IMPROVEMENT PERMIT DENIAL

Re: Application for Improvement Permit for property located at 9202 ELGIN DR , CHARLOTTE, NC 28214
Parcel No.: 05507210
Health Department File No.: SEP-016455

SOIL/SITE EVALUATION for ON-SITE WASTEWATER SYSTEM

PROPOSED PLOT PLAN

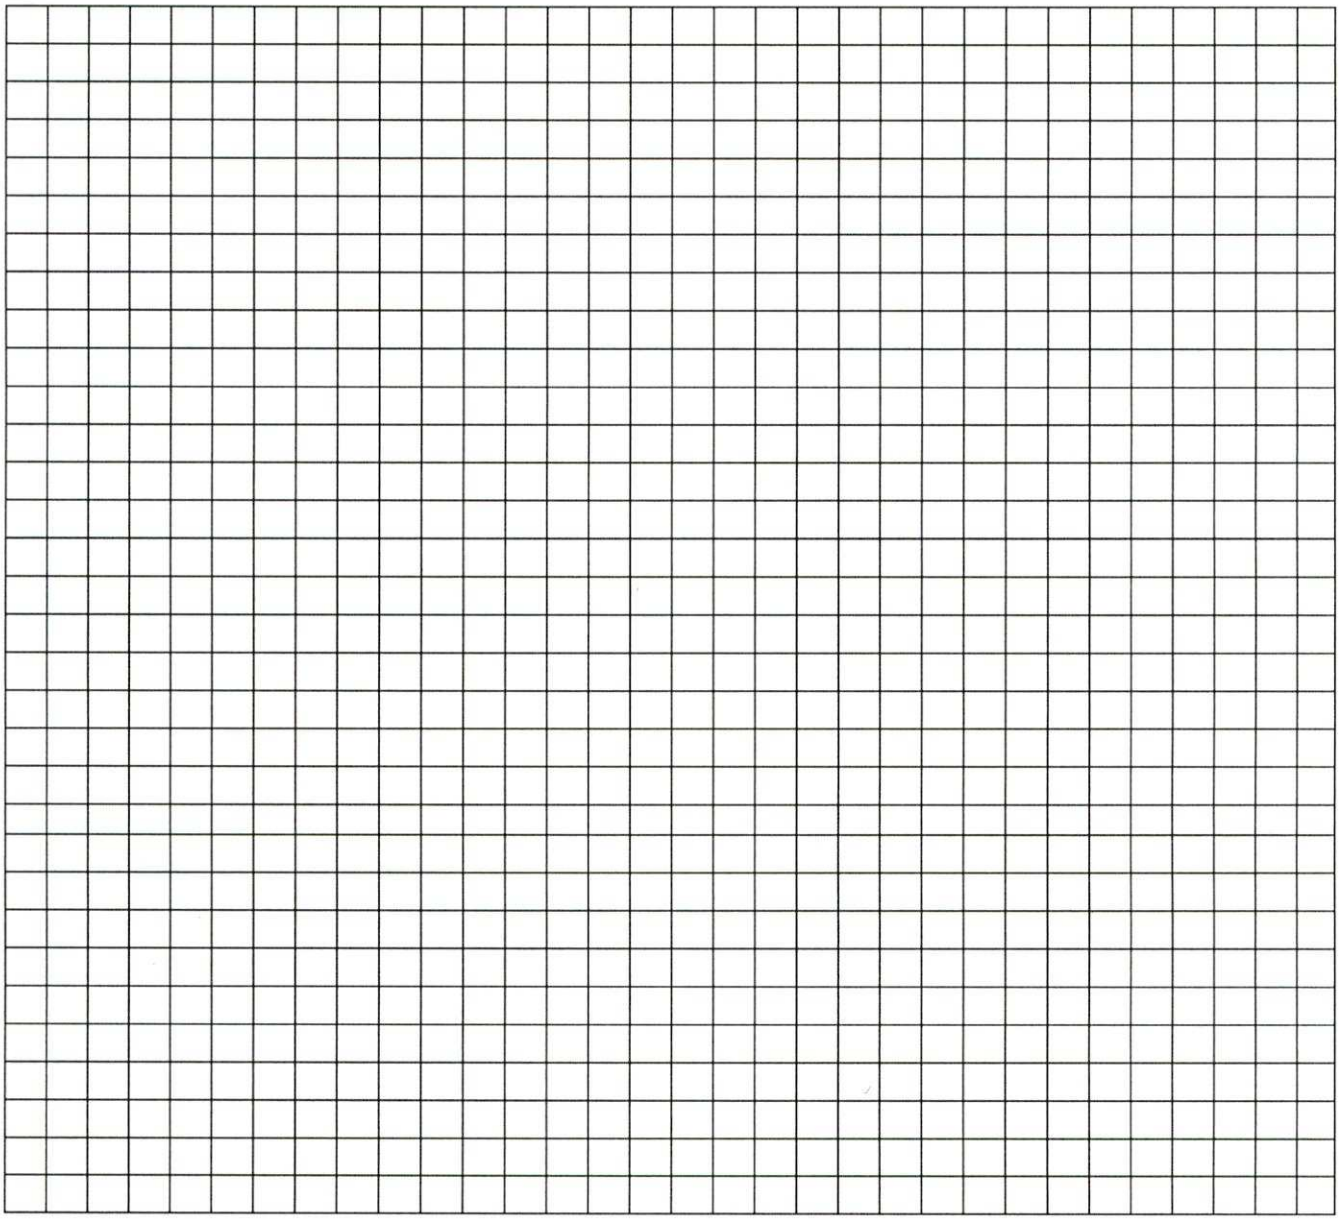
COMMENTS: Due to the presence of unsuitable soil characteristics (soil wetness, exp. clay, US saprolite) and shallow allowable depth in the one boring that was suitable (boring #2), there is insufficient space to accommodate an addition for a 3 BR SFR system. Furthermore, the private inspector reported backflow from the drainfield into the septic tank during inspection.
